REGIONAL REVIEW FINDING

ARC REVIEW CODE: R1602041

Name of Proposal: Ridgewalk Landing

SUBJECT: **Transportation Division Review of DRI # 2520**

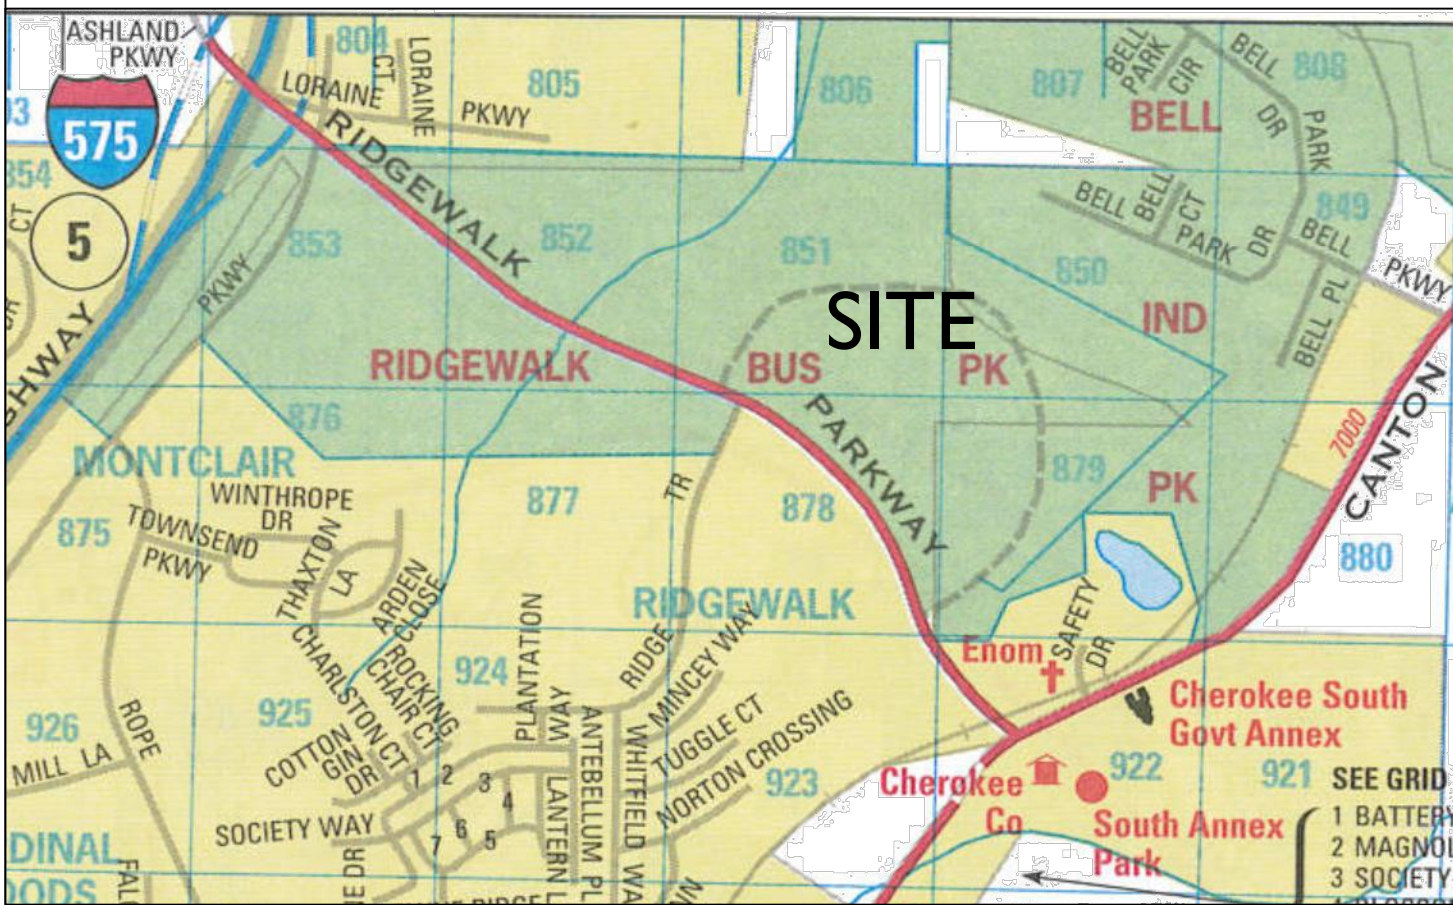
The proposed development plan features a mix of commercial, office, residential and civic space. This format will create the potential for site users to park once and conduct multiple trips on foot. However, commercial uses on either side of the site are separated from each other by large surface parking lots and main site driveways. Care should be taken to ensure that sidewalk connections between these uses and throughout the site are clearly marked, safe and comfortable for pedestrians. This will encourage walking trips between uses, minimizing dependency on cars for internal site circulation. To reduce area-wide traffic and vehicle miles traveled (VMT), the developer should follow through with constructing on-site bicycle parking facilities as planned. The addition of bicycle access into and out of the site – via protected lanes or similar methods – would also help reduce traffic and area-wide VMT while capitalizing on the adjacent Greenprints Trail and Woodstock's overall multi-use trail network. This is something the City and the developer should consider.

The development plan also proposes a large surface parking lot that fronts on Ridgewalk Parkway. While it appears that the lot is planned to sit higher than the level of the Parkway due to site topography, the developer and the City of Woodstock should explore strategies for minimizing the visual impact of this surface parking.

We have discussed a trail connection with the applicant through the site to connect Olde Rope Mill park to Ridgewalk Parkway. We continue to recommend this connection, working with the applicant to arrive at the proper placement.

The applicant should seek the opportunity to tie into roads on properties adjacent to the northern tract to add relief from having to enter/exit Ridgewalk Parkway.
